National Highways Authority of India

NHAI/PIU-PALM/HP/11016/12/Forest/2022-23/1236

Sub: Diversion of 7.1203 hectare of forest land for rehabilitation and up-gradation to Four Lane configuration & Strengthening of Sihuni to Rajol from Kms. 51/00 to 72/00 (Package-IIA) (Design Length 18.450 Kms) of NH-20 (New NH-154) of Pathankot-Mandi Section in the State of Himachal Pradesh within the jurisdiction of Nurpur, Dharamshala & Dalhousie Forest Divisions in District Kangra & Chamba (Online Proposal No. FP/HP/Road/152261/2021).

In this connection, it is submitted that the point-wise reply to the observations raised by GoI is furnished as under:-

Annexure - F

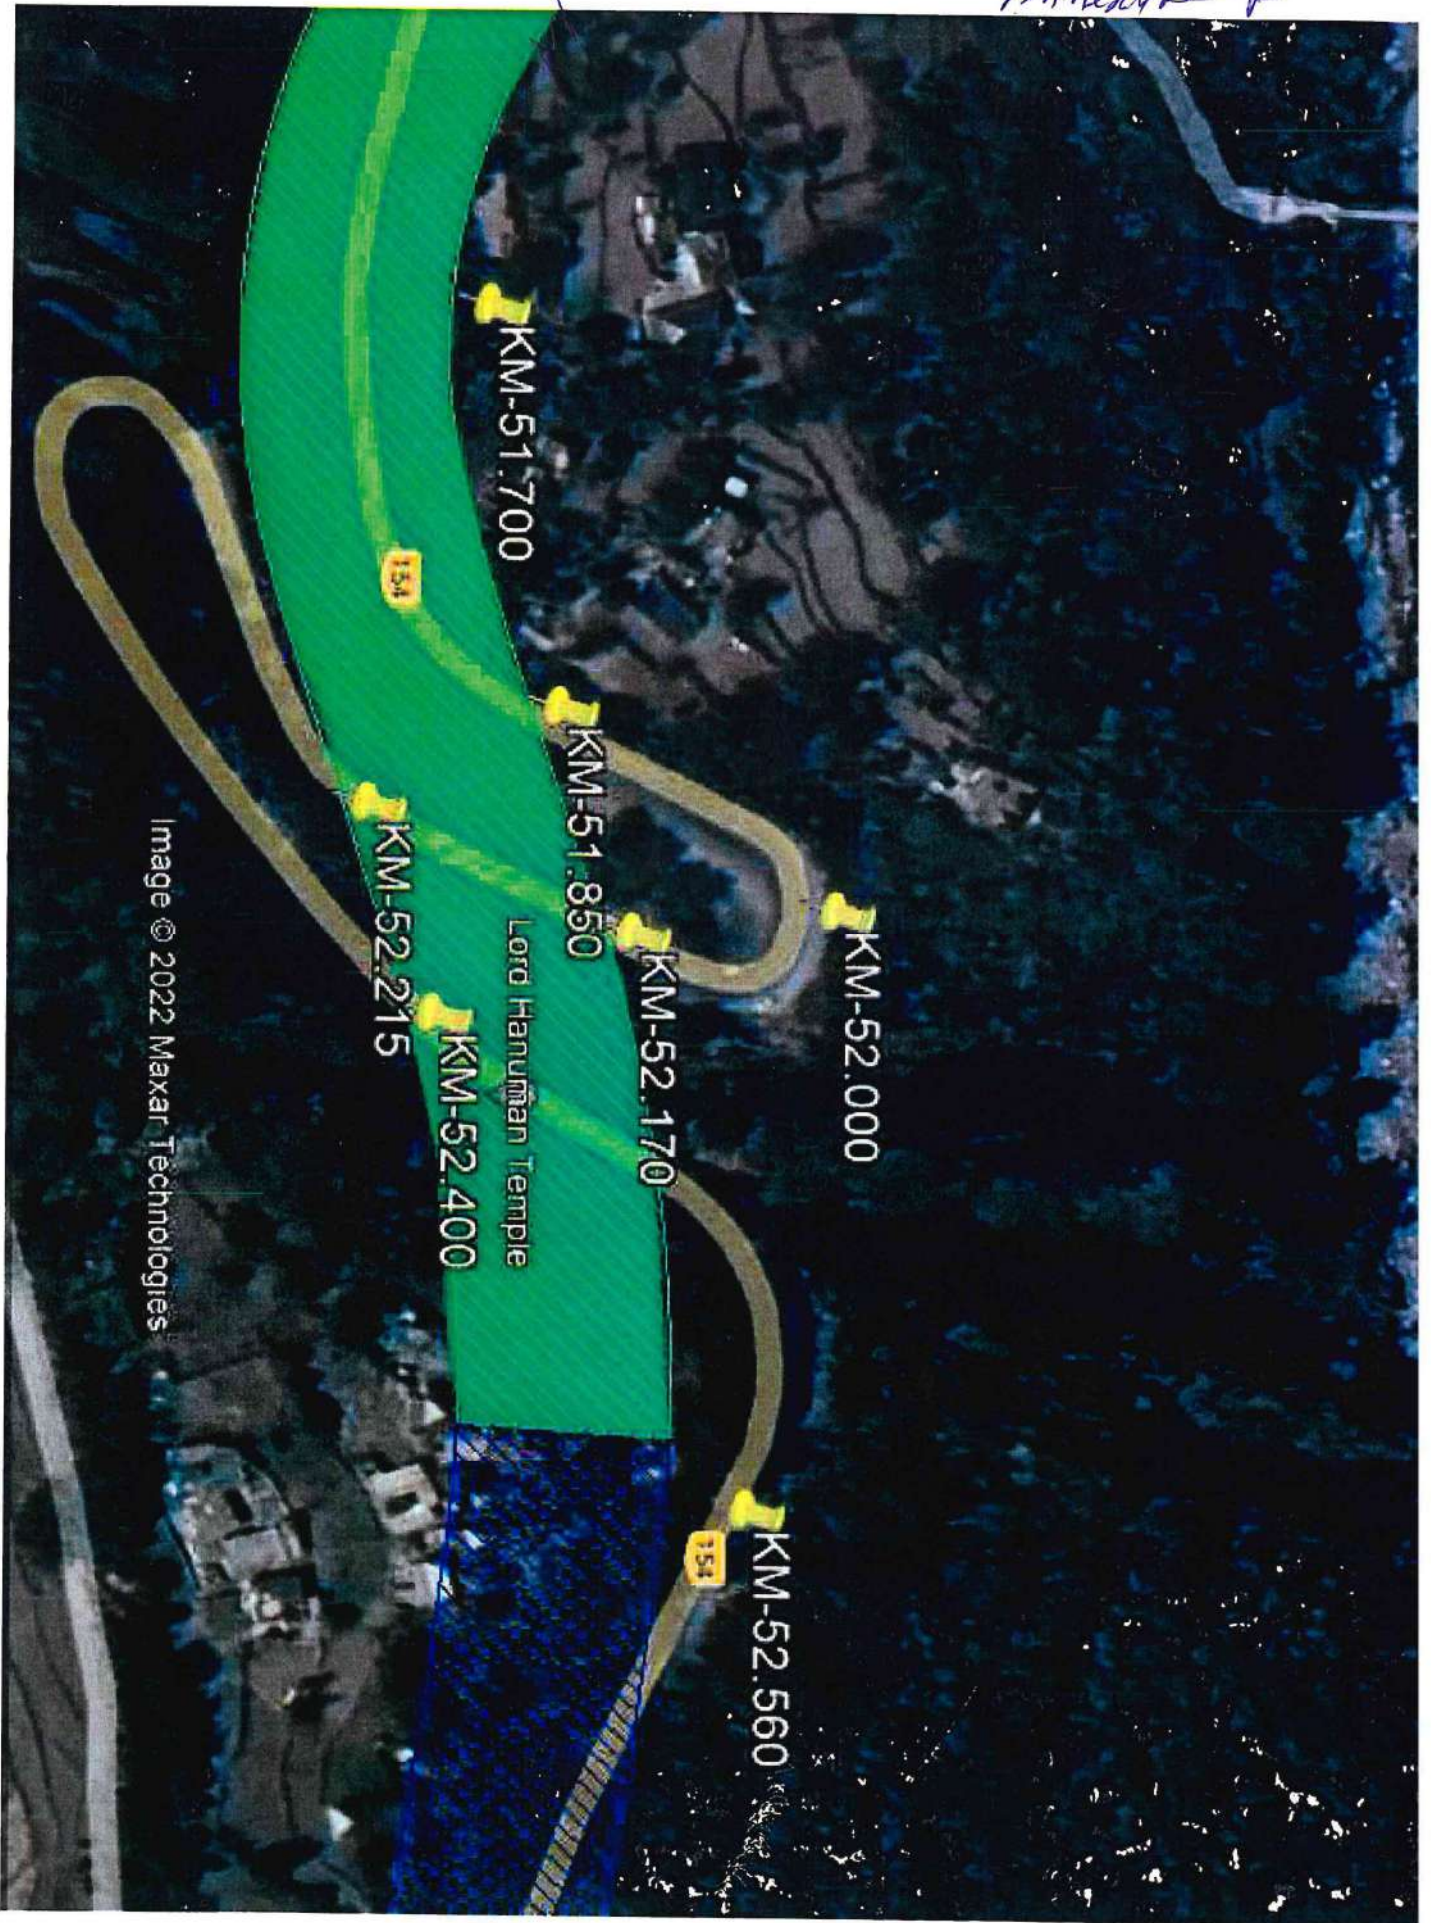
10. The necessary action may be done by the concerned Divisional Forest Officer's.
11. There is an "S" curve from KM 51.700 to KM 52.560 on existing highway. To improve the geometry of the road as per IRC SP-84 standard the "S" curve has been improved. Due to which stretch of existing highway from KM 51.850 to KM 52.170. and KM 52.215 to KM 52.400 has been excluded from the PROW. The sketch is attach as annexure-F

Figure: 1 MDS-1 Villages Lalesar & Ranoohn

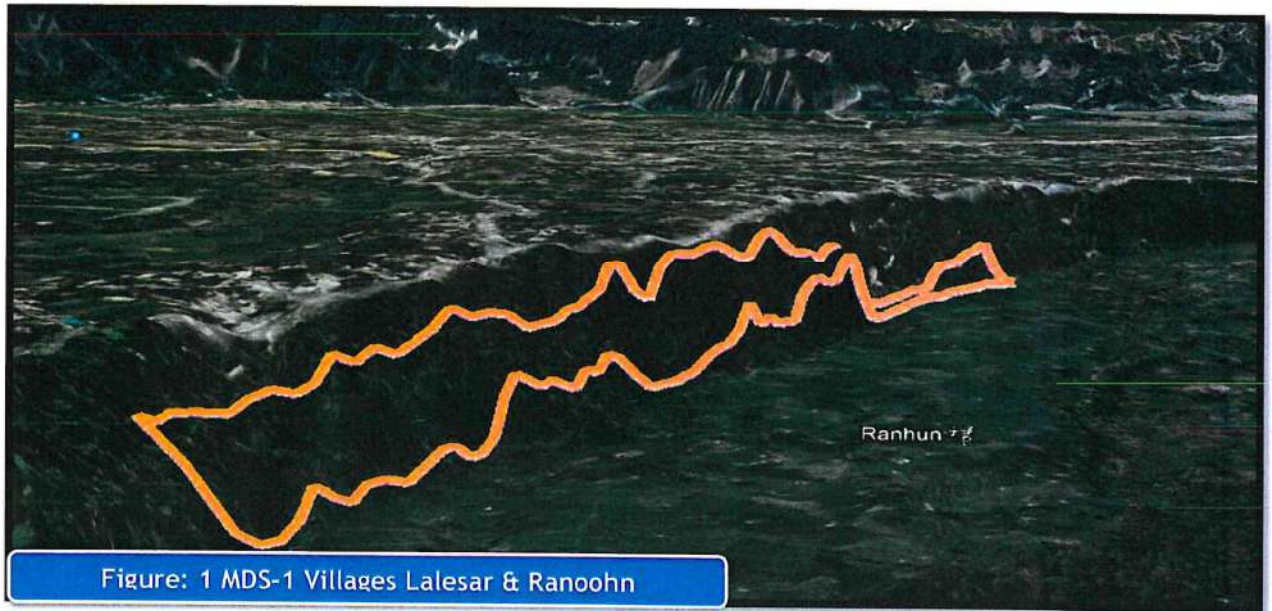
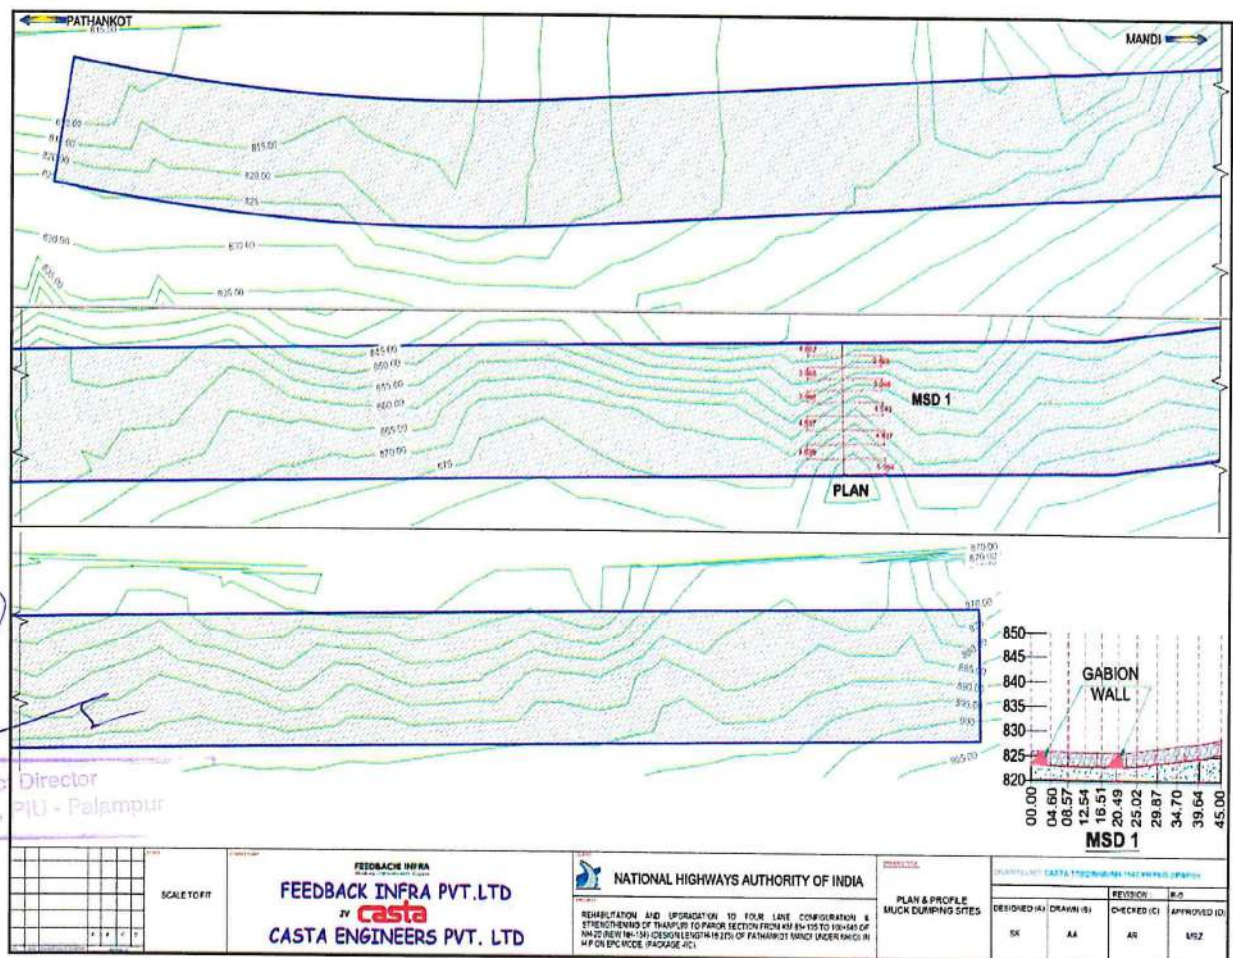
Moreover, Digital elevation models, as presented in **Figure 1** of the one (01) selected muck disposal sites, were prepared for all muck dumping sites to ascertain the topography and determining the location and length of the gabion wall for slope protection so as to prevent the muck from reaching into natural streams.

Figure: 3 Generate Muck Volume Vis -a-Vis's capacity of Disposal sites

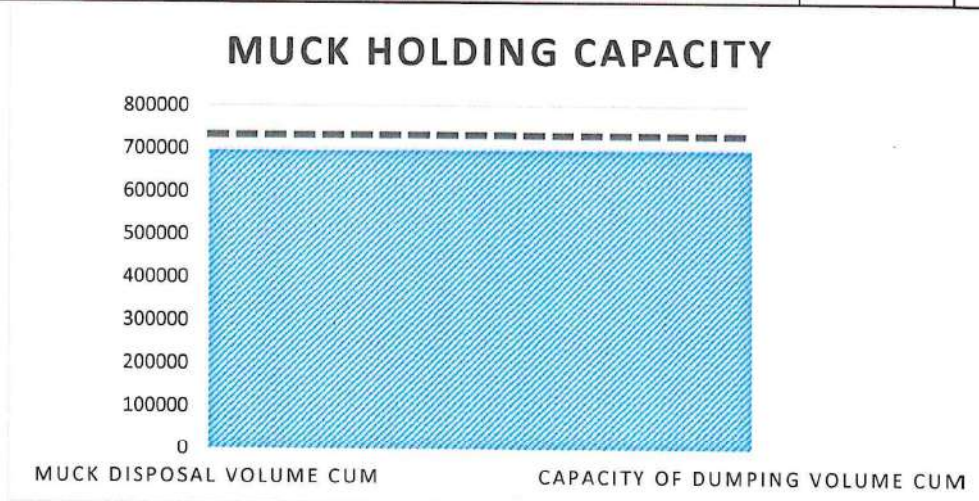
It can be inferred from the Figure 3 above that capacity of the disposal sites fulfils the requirement of generated muck volume. Therefore, the proposed muck disposal sites with the suggested gabion wall height will suffice the requirement of dumping of excavated muck.
